B1 to B4 Rehab

Assessment of Reused Components

Commission Presentation

August 7, 2017

Pole L Bracket FEA

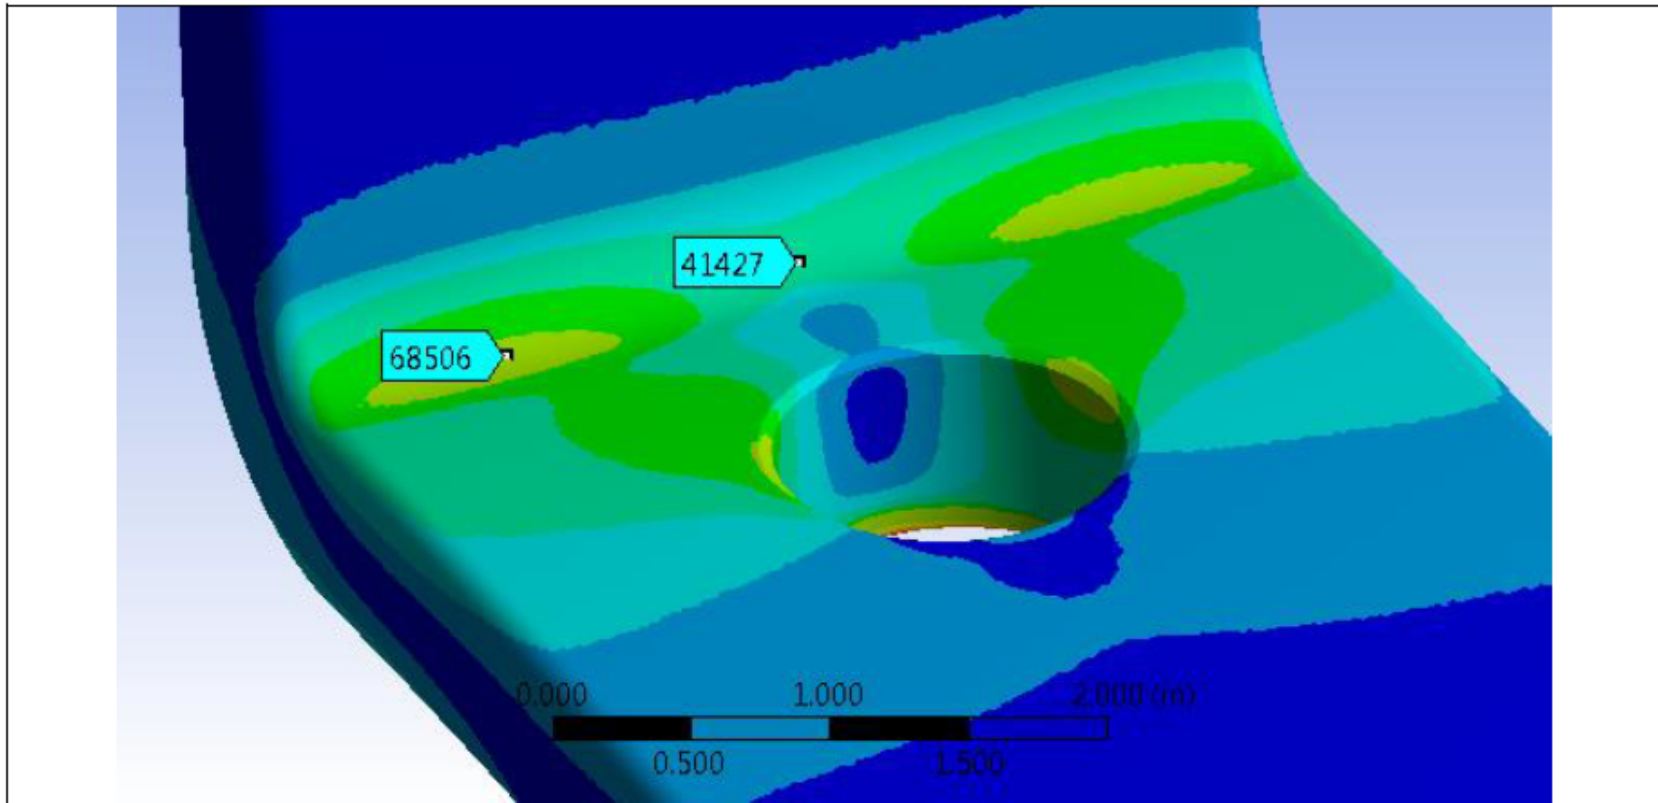
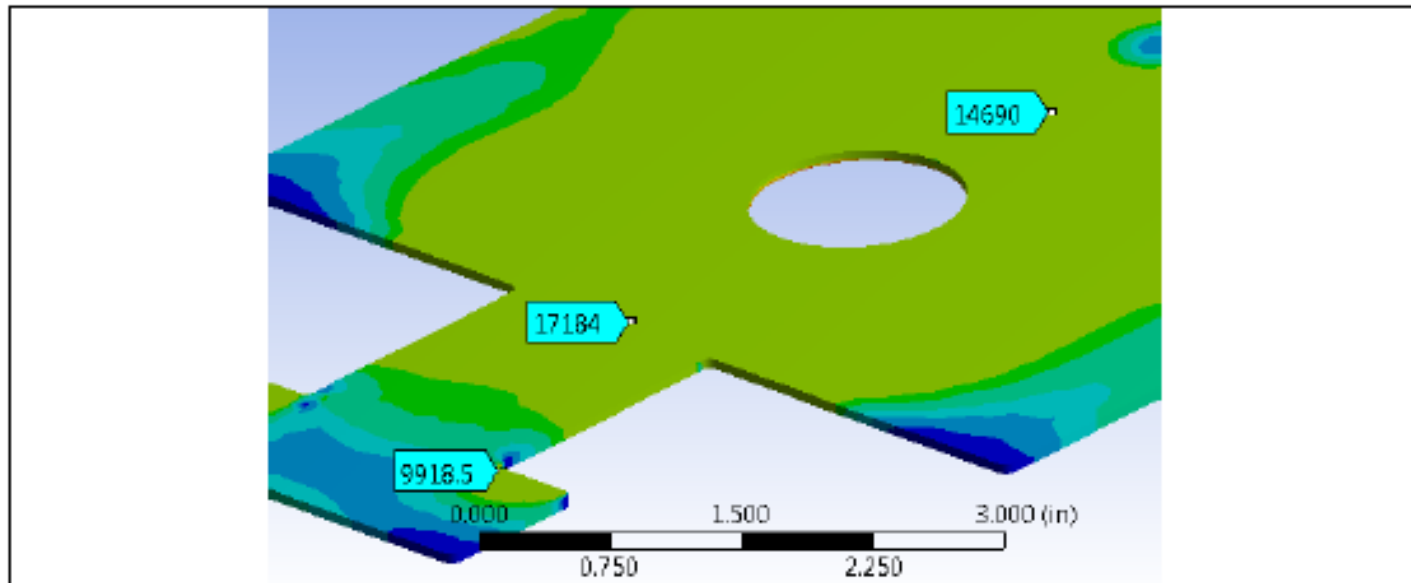
Von Mises stress in top side of endplate radius at runaway.

Bulk: $P_L + P_b \in (41.4\text{ksi}, \dots 68.5\text{ksi}) \gg 1.155 \times 0.667 \times S_y = 31.6 \therefore$ not acceptable per contract

This region is under serious risk of plastic collapse during runaway speed.

Local: $P_L + P_b + Q + F = 68.5\text{ksi} \rightarrow$ fatigue analysis conducted for completeness

Pole Body Defects

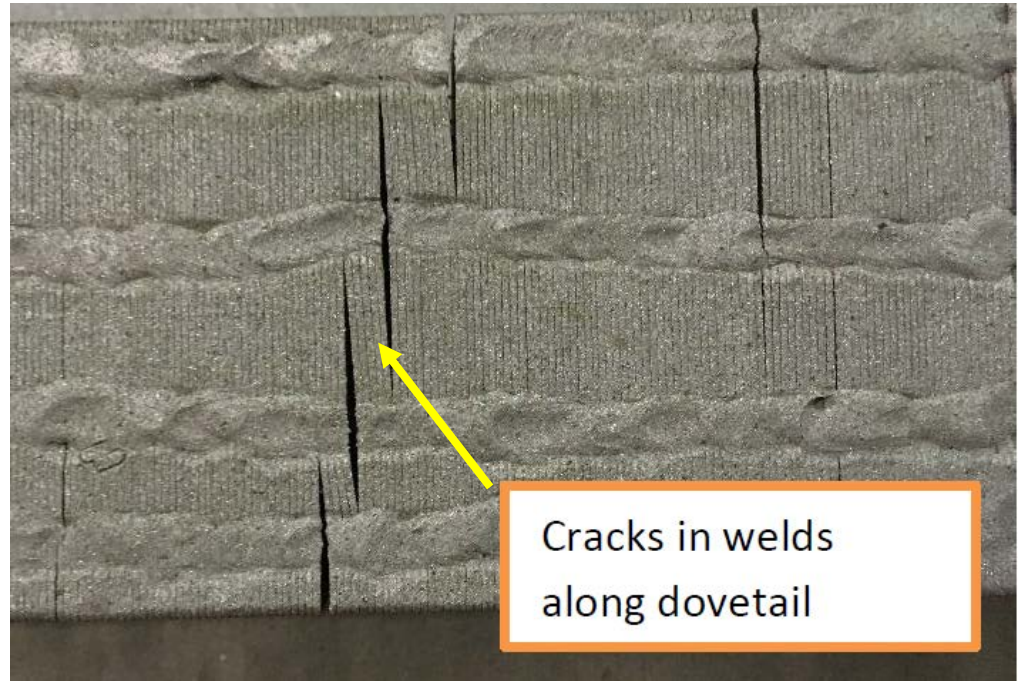
RIVET CRACKS

Cracks in welds
along dovetail

LOOSE RIVETS

- Contract has option for new poles at \$1.15 million per unit additional cost (\$1.65M).
- Recommendation – Because of cracks in material and overstress at runaway, propose to replace pole body and reinsulate winding all 4 units.
- Cost estimated at \$750k per unit additional cost (\$1.25M).

B4 copper winding after insulation removal

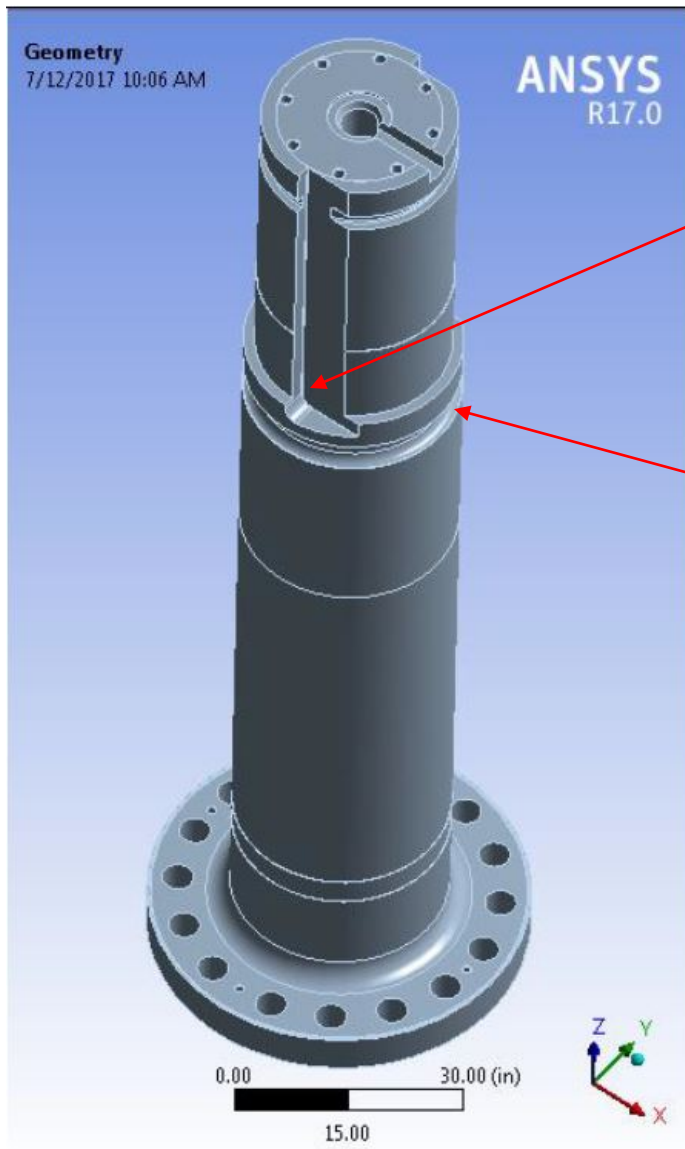
- Condition assessment performed for rotor poles. 6 poles removed for evaluation.
- Problems (similar in all 6 of 72 inspected)
 - Rivets: some cracked and loose
 - Dovetail: cracks in welds
 - 90% probability pole body will not last 50 years
 - Winding: copper looks to be reusable if reinsulated.

Gen shaft FEA at rotor keyway

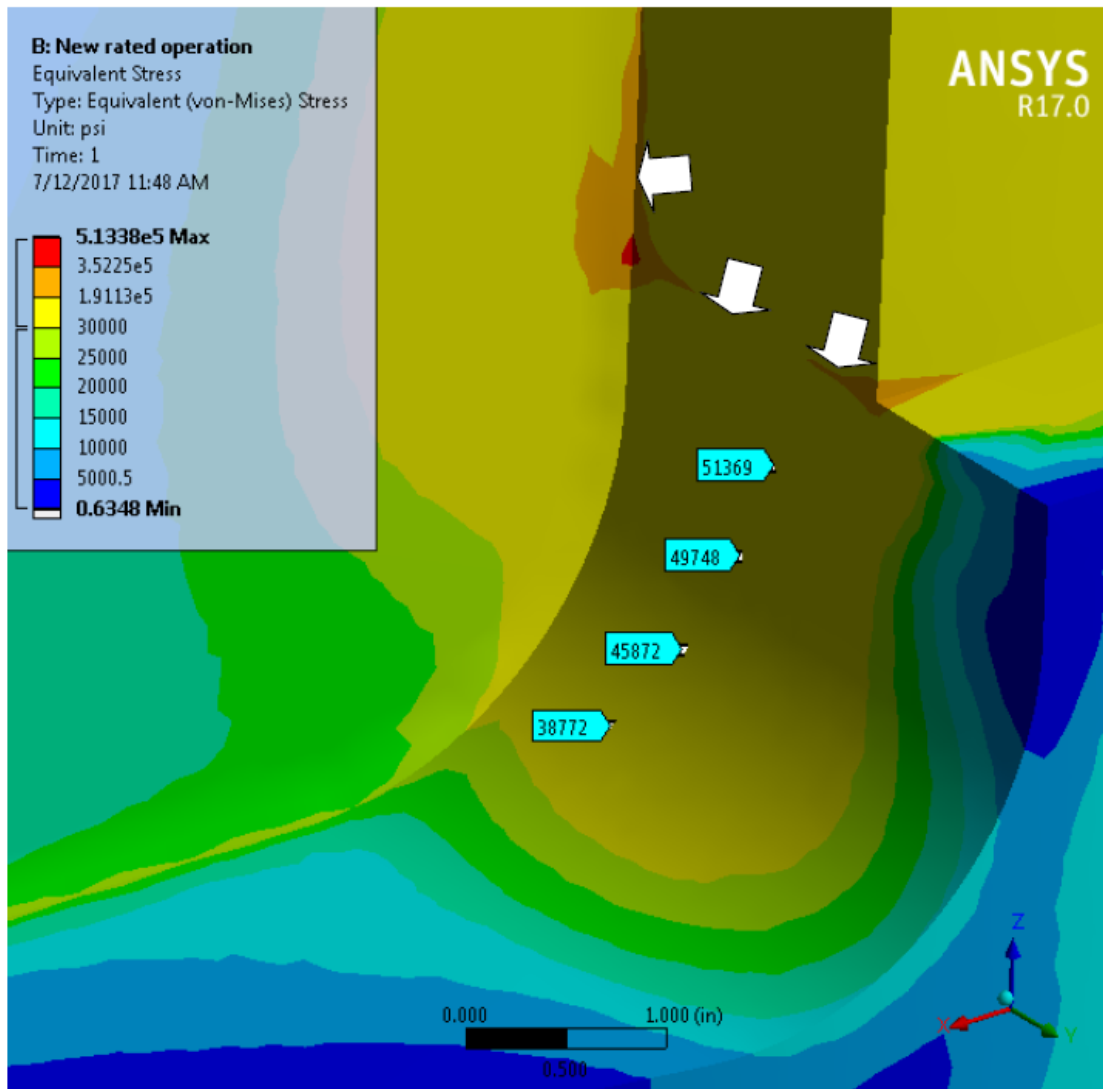
Figure 15: Von Mises stress in bottom of torque keyway at new rated operation.

Local: $\sigma_L + \sigma_b + \sigma_Q = 51\text{ksi} > 0.8 * 1.5 \sigma_{all} = 24\text{ksi}$: static stress not acceptable

- Recommendation – Purchase new gen shaft all 4 units
 - Benefits are that \$100k goes to new purchase with full 50-yr life and no schedule impacts.

Gen shaft FEA at axial thrust keyway

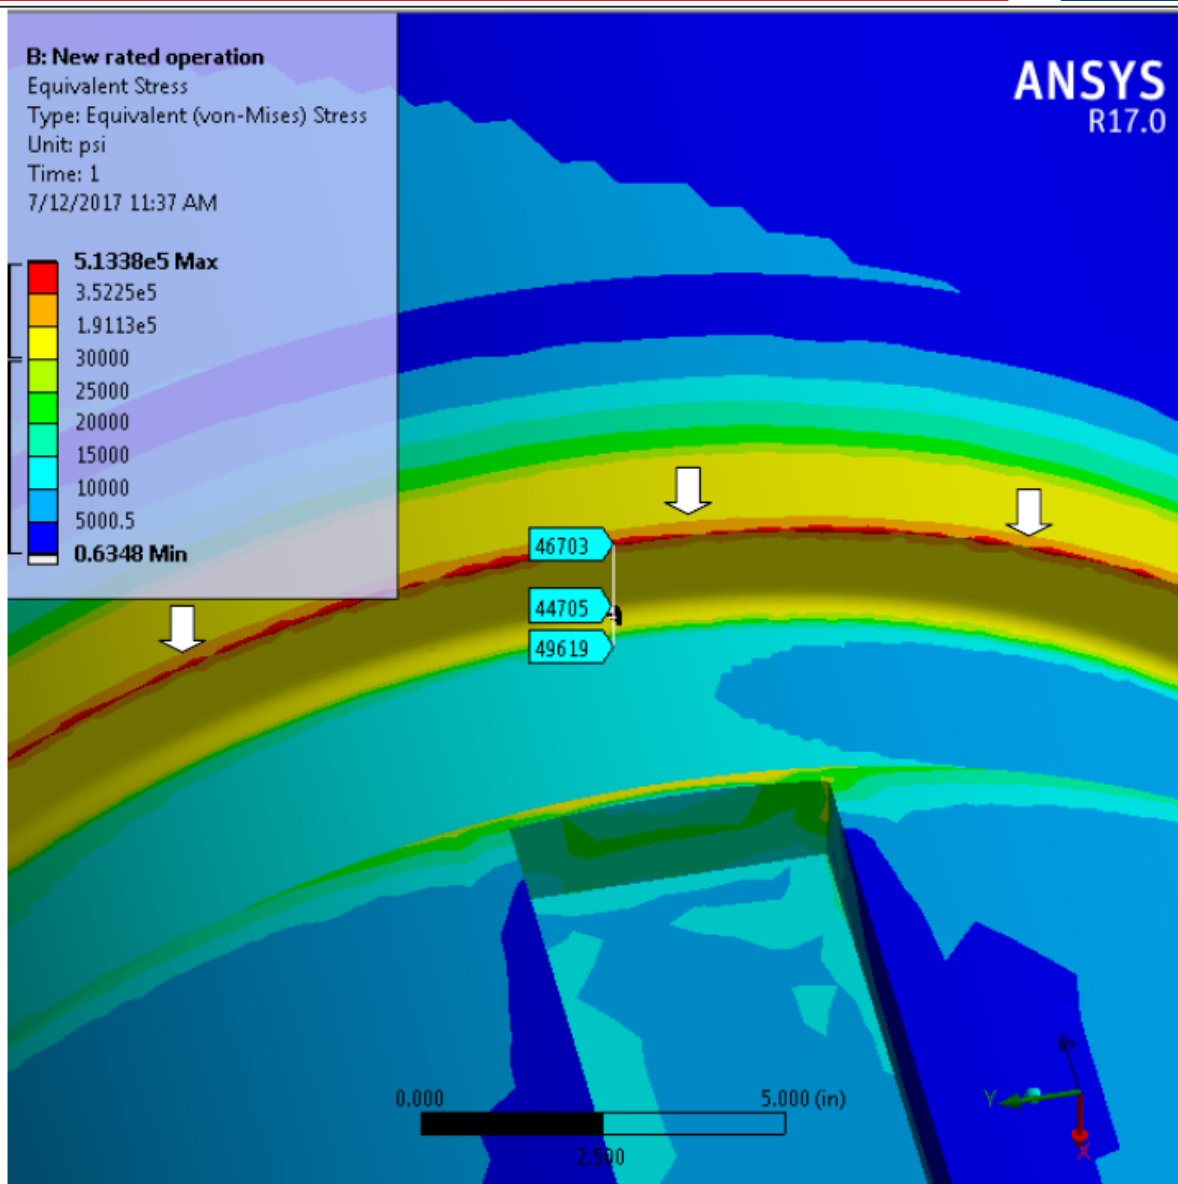
Figure 14: Von Mises stress in top radius of axial thrust keyway at new rated operation.

Local: $\sigma_L + \sigma_b + \sigma_Q + \sigma_F = 50 \text{ ksi} > 0.8 * 1.5 \sigma_{all} = 24 \text{ ksi}$: static stress not acceptable
 → fatigue analysis required

Wicket Gate Stem Stresses

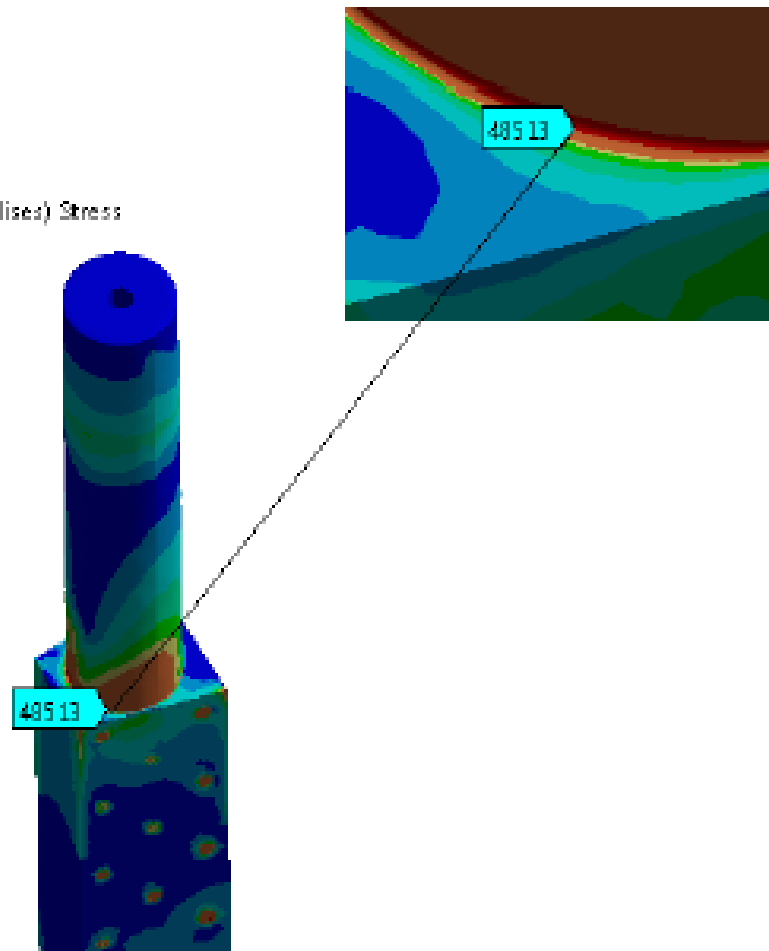
9.1.7 Wicket Gate Upper Stem Von Mises Stress

Equivalent Stress Stem
Type: Equivalent (von-Mises) Stress
Units: psi
Time: 1
Max: 51599
Min: 37.622

- Contract has option for new wicket gates at \$575k per unit additional cost.
 - FEA recommends stem machining est. at \$100k per set, which is extra work.
 - Extra work also would include crack repair, stem straightening, additional sleeves.
 - 50% chance repairs similar to B2 found on the other 3 units (\$175k).
 - 90% probability gates won't last 50 years.
 - 50% chance gates last 20 years.
 - Undefined risk – if corrosion fatigue of wicket gates is similar to blades, then all gates may be very near end of life.
- Recommendation – Purchase 3 sets of new wicket gates. Reuse B2 wicket gates.
- Benefits are that \$275k goes to new purchase with full 50-yr life and no schedule impacts
